PCN#20191122000.1

Qualification of additional Fab site (RFAB) and Assembly site options for select devices

Change Notification / Sample Request

Date: November 25, 2019

Sample product shipping label (not actual product label)

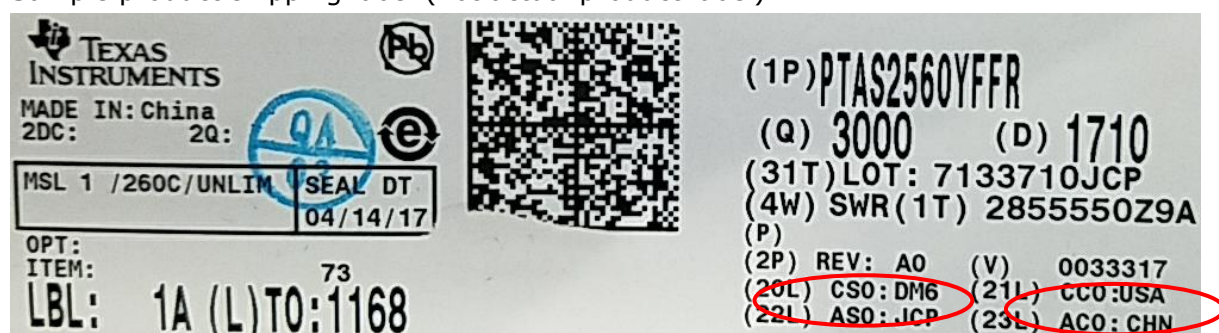
Changes to product identification resulting from this PCN:

Chip Site	Chip Site Origin Code (20L)	Chip Site Country Code (21L)	Chip Site City
FR-BIP-1	TID	DEU	Freising
MAINEFAB	CUA	USA	South Portland
RFAB	RFB	USA	Richardson

Assembly Site	Assembly Site Origin (22L)	Assembly Country Code (23L)	Assembly City
NFME	NFM	CHN	Economic Development Zone
MLA	MLA	MYS	Kuala Lumpur
TIEM	CU6	MYS	Melaka
HNA	HNT	THA	Ayutthaya
ASESH	ASH	CHN	Shanghai
TIPI	PHI	PHL	Baguio City
HFTFAT	HFT	CHN	Hefei
